# CITY OF WESTMORLAND

*WATER DISTRIBUTION PIPING*

*BID No. 2025-01*

## **ADDENDUM NO. 1**

DWR-SCDRP- Water Distribution Piping Replacement SHEET 3 OF 7  
**3RD STREET BETWEEN C STREET AND G STREET**  
**3RD STREET BETWEEN G STREET AND S CENTER STREET**  
 IN THE CITY OF WESTMORLAND, CA DATE: 12/12/2024 BY: R.W.  
 CLIENT: CITY OF WESTMORLAND JOB NO.: 23-105

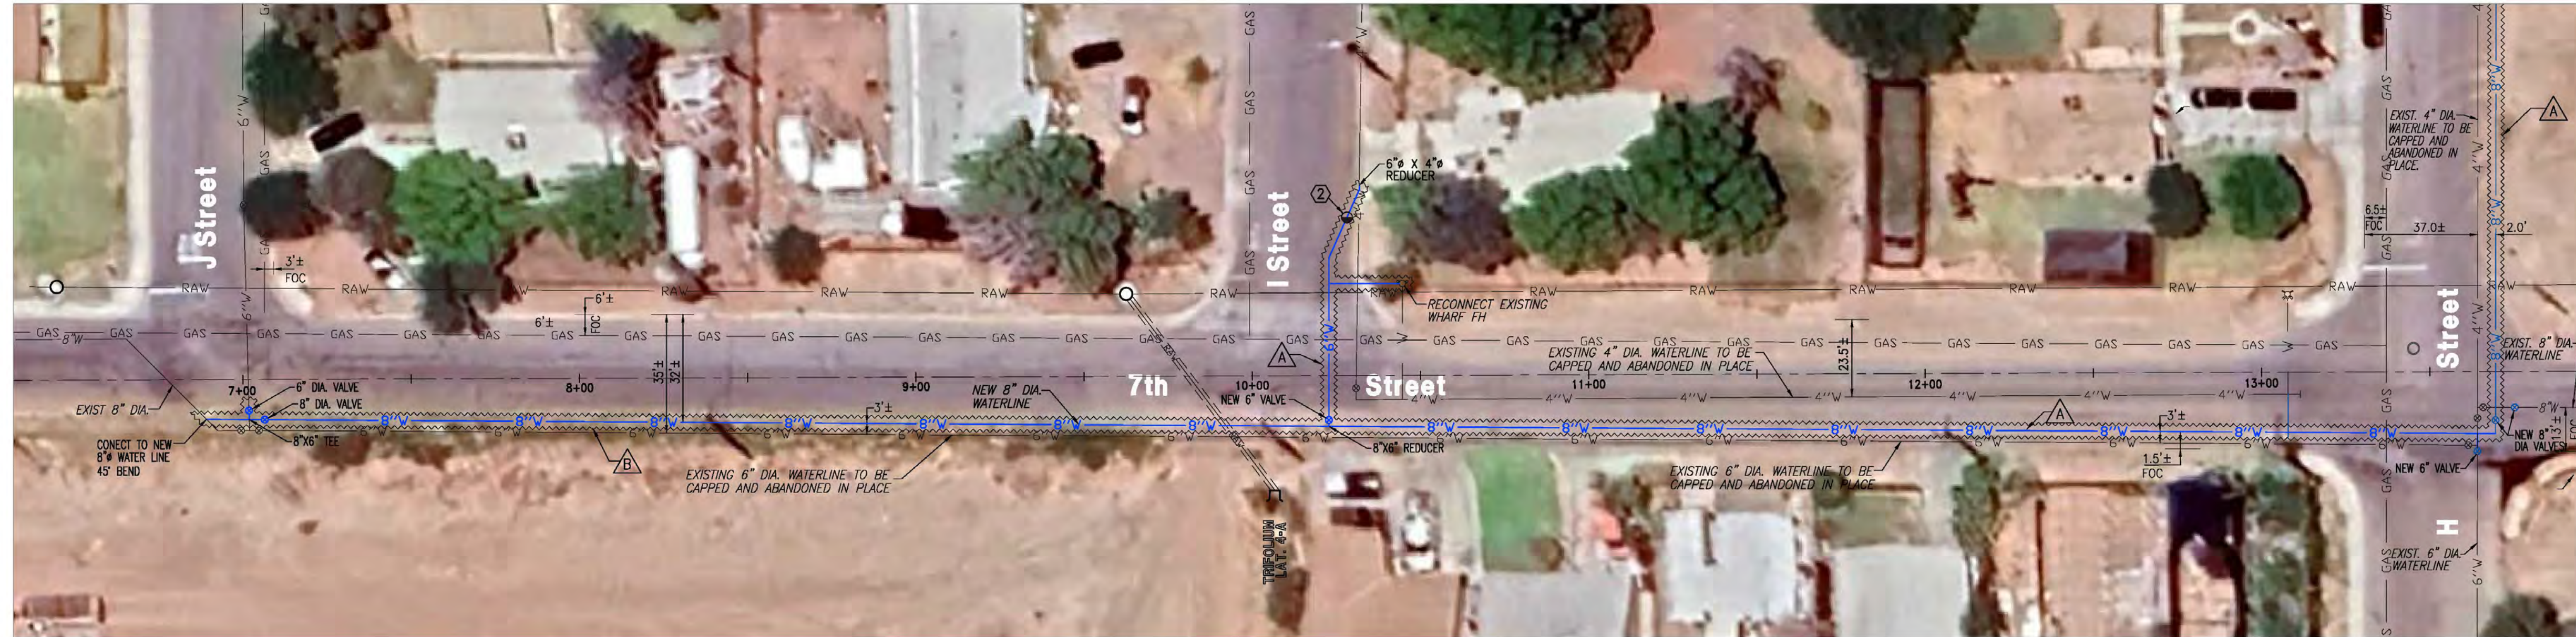
Plan Sheets 3 and 5 are for future projects. The bidder shall not include these plans as part of their bid.

THRUST BLOCKS DETAILS  
WATER TRENCH DETAIL N.T.S. 2

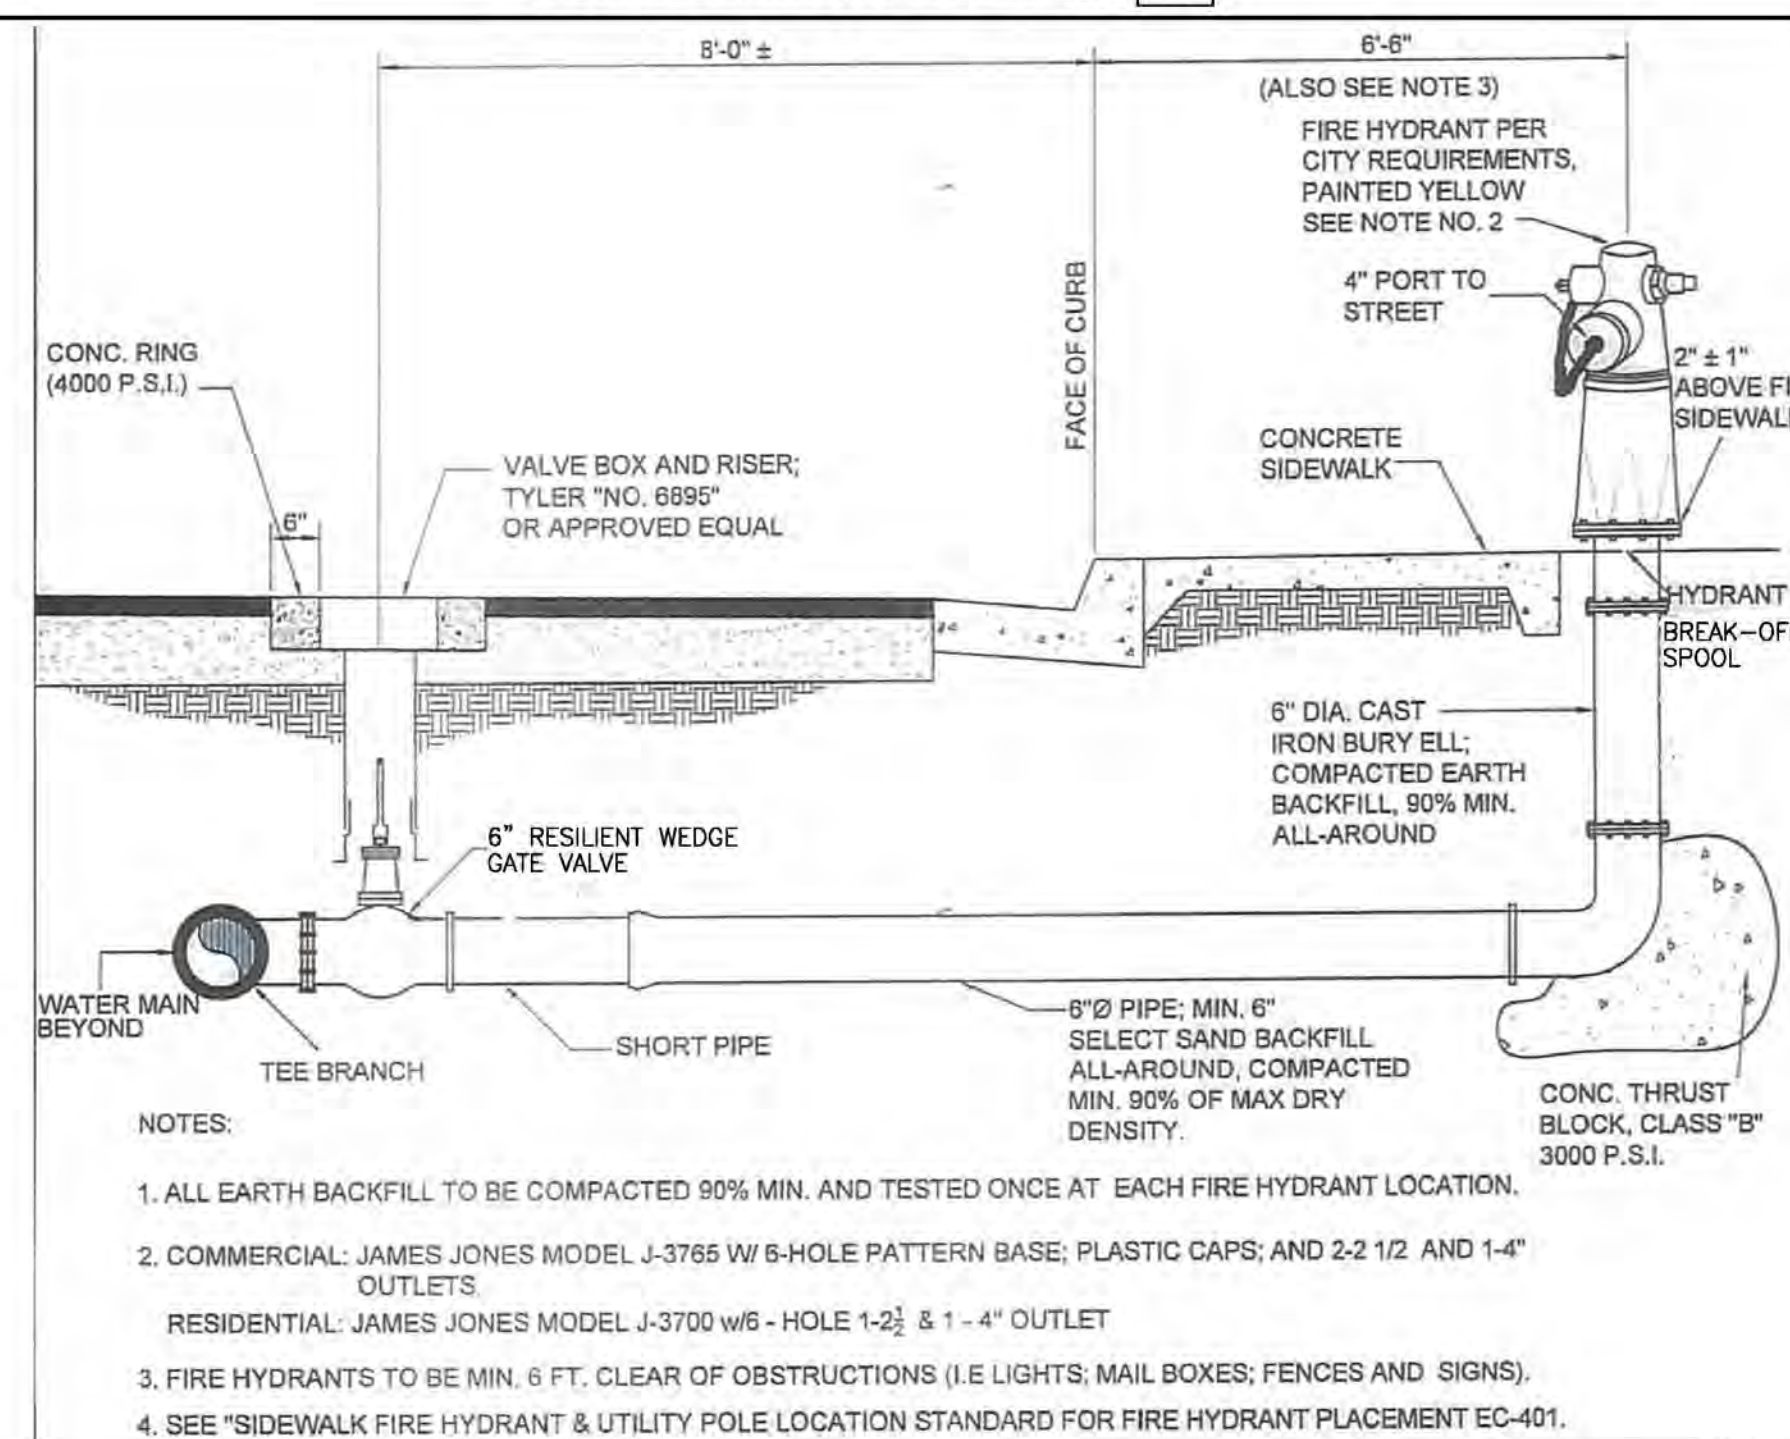
**9. Regarding Pipe trench backfill:**

The asphalt concrete pavement section shall be 4 inches of ½-inch hot mix asphalt concrete over 9 inches of class 2 aggregate base.

The area of pipeline trench along 7<sup>th</sup> Street between H Street and J Street shall not be paved with asphalt concrete pavement. Such trench section is to be backfilled with class 2 aggregate base up to the top of the adjacent pavement surface. Where the new pipeline trench is located outside of asphalt pavement, native soil shall be used to backfill to the top of the adjacent native surface.
